NUMBER: SB 500-54-004, Rev A
MODEL: ECLIPSE EA500
SUBJECT: VORE Lower Louver Skin Drainage

This Service Bulletin been prepared to improve drainage in the VORE area.

This Service Bulletin provides procedures to add drainage holes to the VORE Lower Louver Skins.

**Left Louver (Right Side Opposite)
Figure 1**

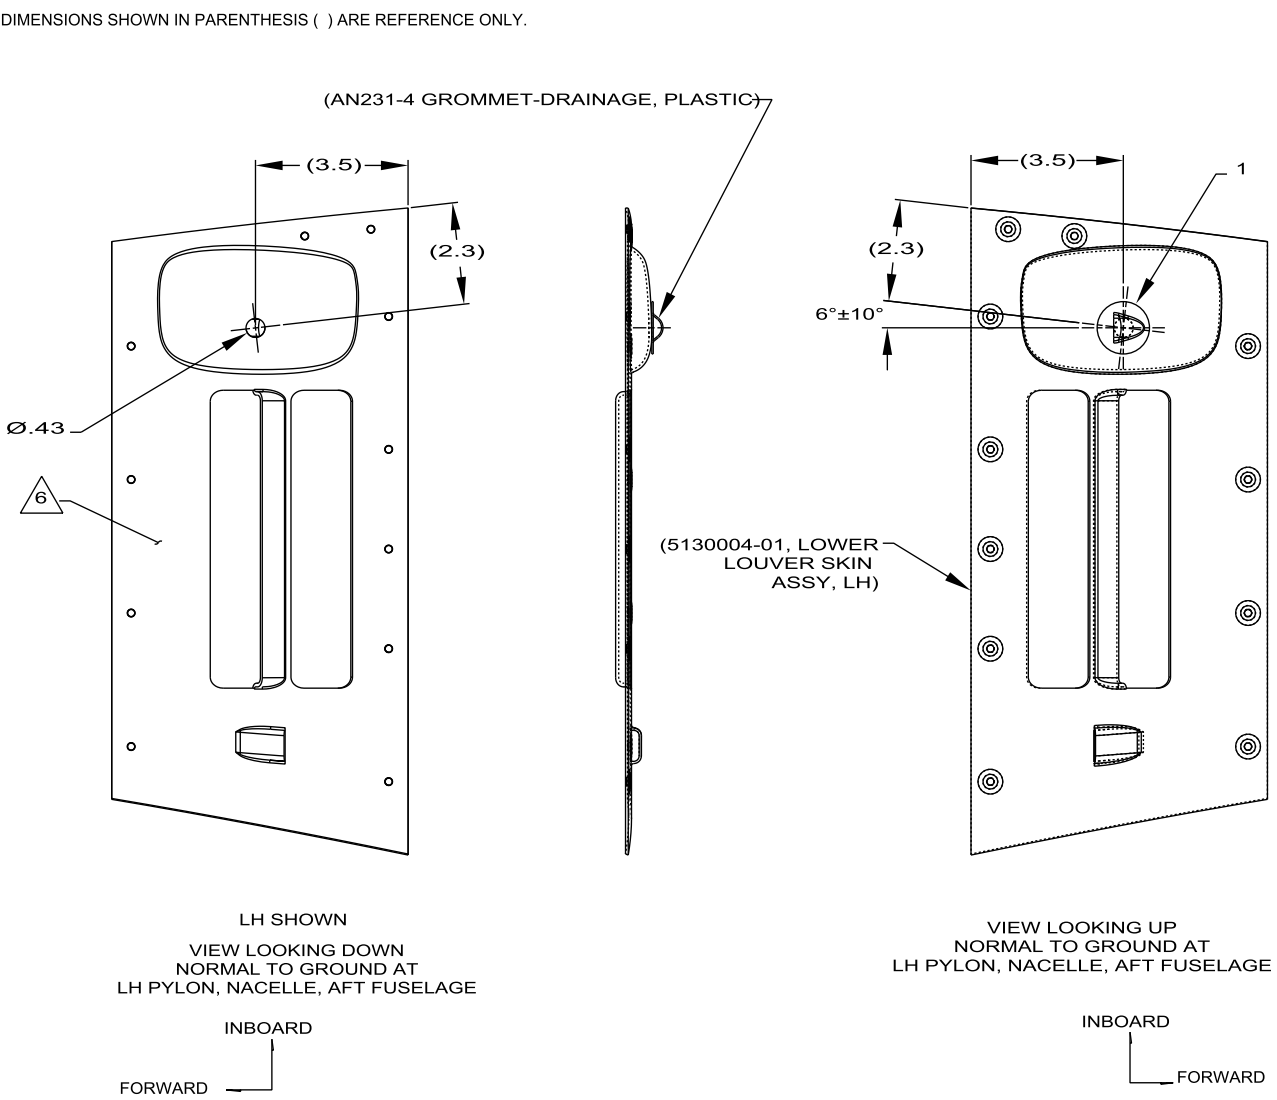
- (1) Make the aircraft safe for maintenance. Refer to AMM 20-00-01 MAKE SAFE FOR MAINTENANCE. _____
 - (2) Level aircraft. Refer to AMM-07-10-00 - JACKING - MAINTENANCE PRACTICES and AMM-08-20-00 - LEVELING. _____
- NOTE: Jacking the aircraft may be required to level the aircraft.
- (3) Locate and mark position for center of hole at the lowest point at the pocket located on Left Lower Pylon Louver Assembly - 311 KL and Right Lower Pylon Louver Assembly - 312 GR. Refer to [Figure 1](#). _____

Left Louver Panel Rework
Figure 2

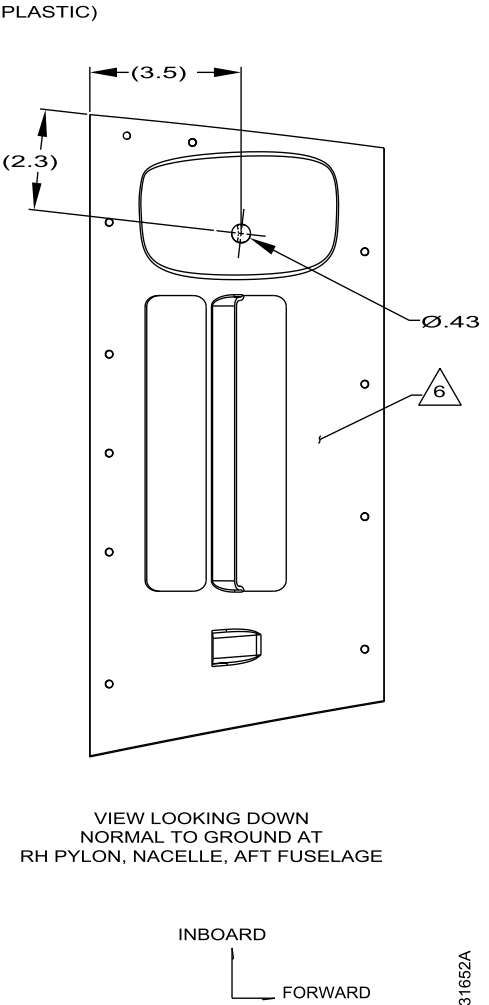
- (a) Locate using mark from step (3) and drill Ø 0.43 hole on Left Lower Pylon Louver Assembly - 311 KL. Refer to [Figure 2](#). _____
- (b) Surface prep the area to be bonded. _____

- (c) Seal exposed edge of hole with Hysol 9396 or equivalent. _____
- (d) Bond Drainage Grommet, P/N AN231-4 (1, [Figure 2](#)) with Scotchweld 2216 or equivalent over new Ø 0.43 hole on outer surface of Left Lower Pylon Louver Assembly - 311 KL. Note direction of opening of Drainage Grommet, P/N AN231-4 in relation to the aft facing edge. Refer to [Figure 2](#). _____

- (e) Fill and blend any areas where the base of the Drainage Grommet, P/N AN231-4 rises above the loft of the convex surface with Scotchweld 2216. _____

- (f) After adhesive has cured, primer and paint reworked area. _____
- (g) Part mark "Modified by SB 500-54-004" with indelible ink in area shown. Refer to [Flag Note 6, Figure 2](#). _____

Right Louver Panel Rework
Figure 3

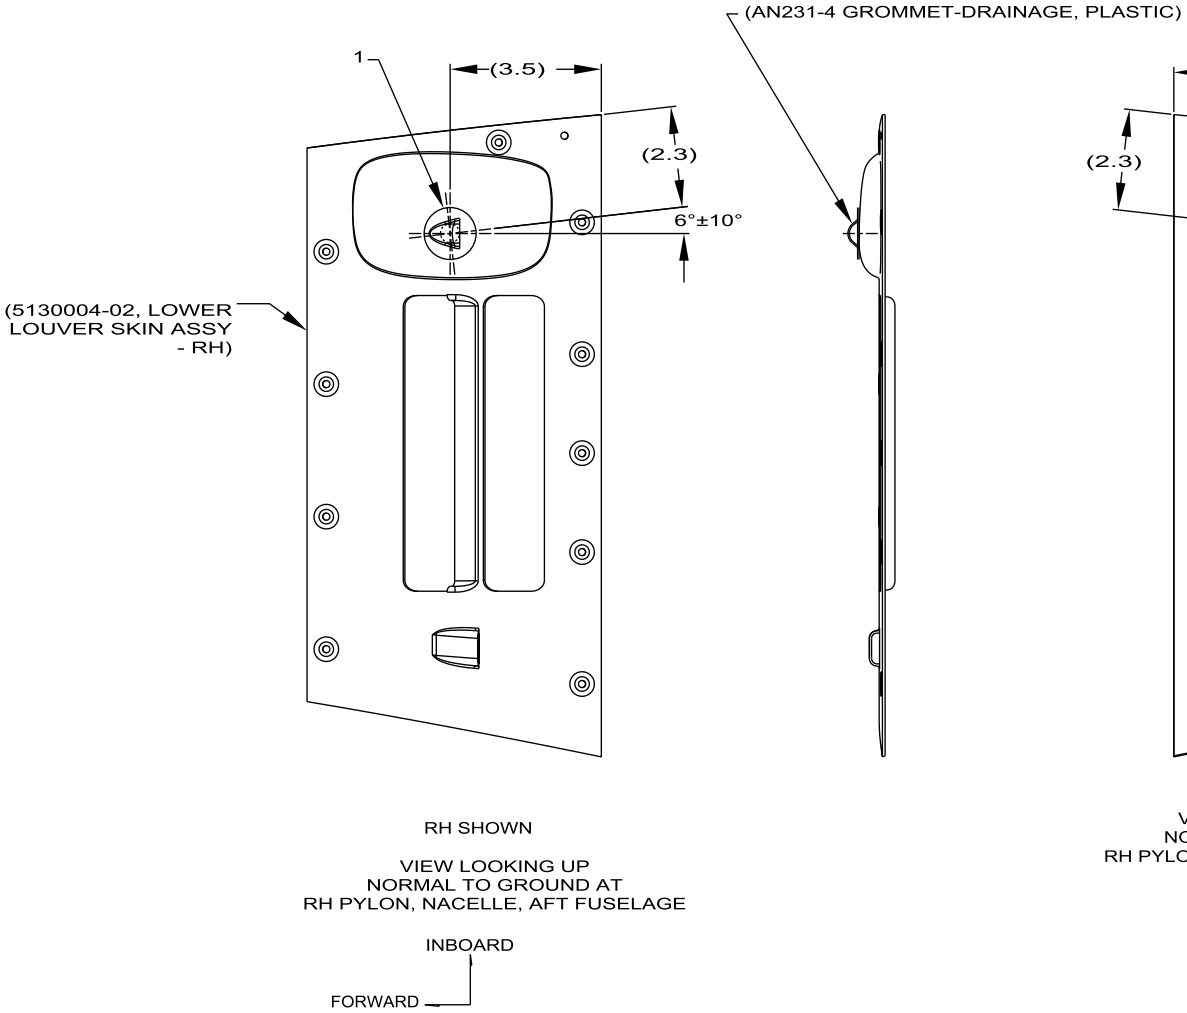
- (a) Locate using mark from step (3) and drill \varnothing 0.43 hole on Right Lower Pylon Louver Assembly - 312 GR. Refer to [Figure 3](#). _____
- (b) Surface prep the area to be bonded. _____

- (c) Seal exposed edge of hole with Hysol 9396 or equivalent. _____
- (d) Bond Drainage Grommet, P/N AN231-4 ([1, Figure 3](#)) with Scotchweld 2216 or equivalent over new \varnothing 0.43 hole on outer surface of Left Lower Pylon Louver Assembly - 311 KL. Note direction of opening of Drainage Grommet, P/N AN231-4 ([1, Figure 3](#)) in relation to the aft facing edge. Refer to [Figure 3](#). _____

- (e) Fill and blend any areas where the base of the Drainage Grommet, P/N AN231-4 rises above the loft of the convex surface with Scotchweld 2216. _____

- (f) After adhesive has cured, primer and paint reworked area. _____
- (g) Part mark "Modified by SB 500-54-004" with indelible ink in area shown. Refer to [Flag Note 6, Figure 3](#). _____
